# Rezoning Transportation Analysis

Petition Number: 2023-027

Date	Description
06-28-23	First Review (PDM)
07-27-23	Second Review (PDM)

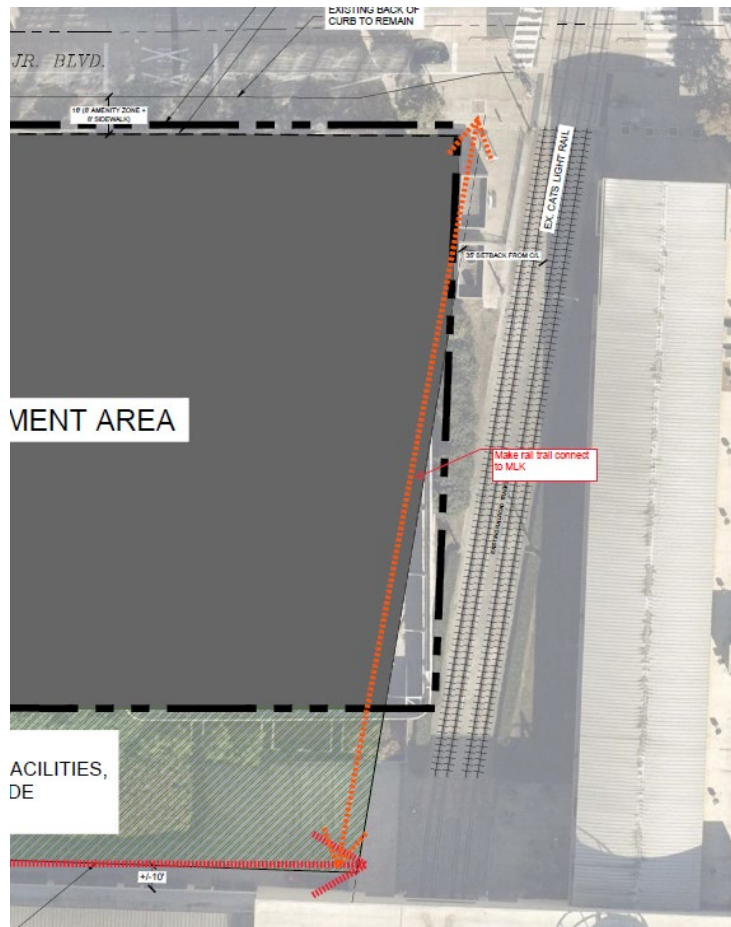
Revise site plan to show the proposed sites access locations and types.

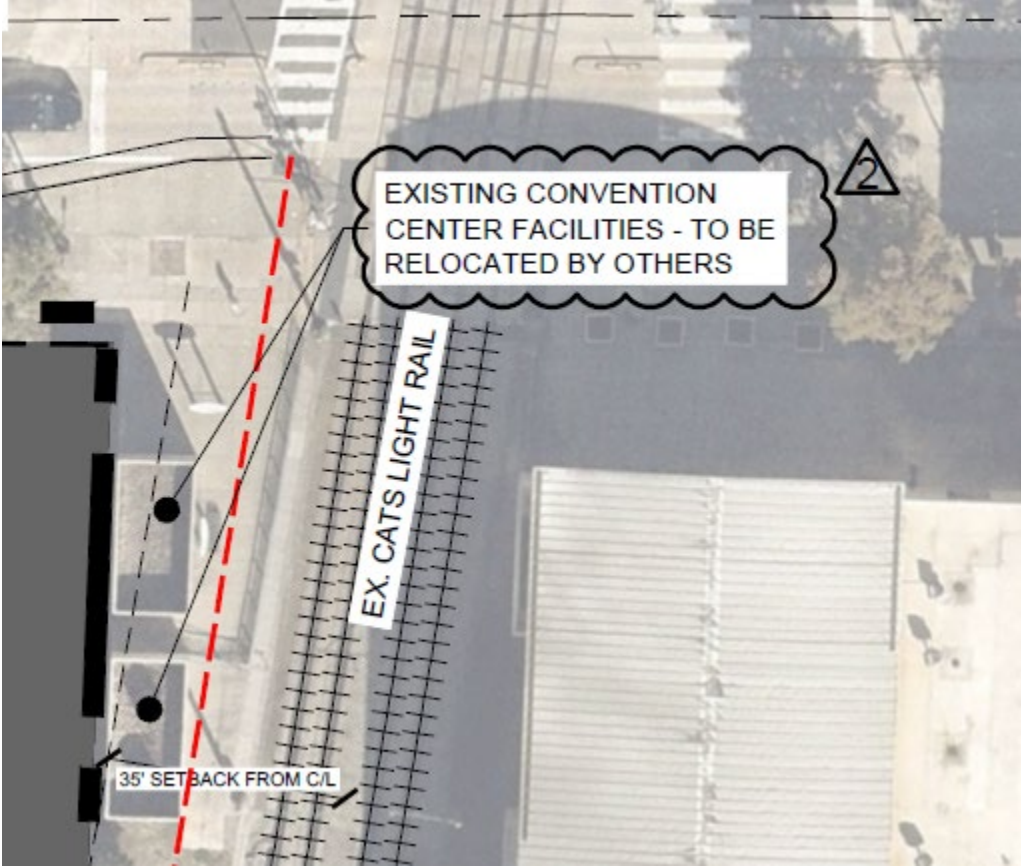
Revise site plan to add more clarity to the area below that is outside of the property line but part of the rezoning. Is this public ROW?
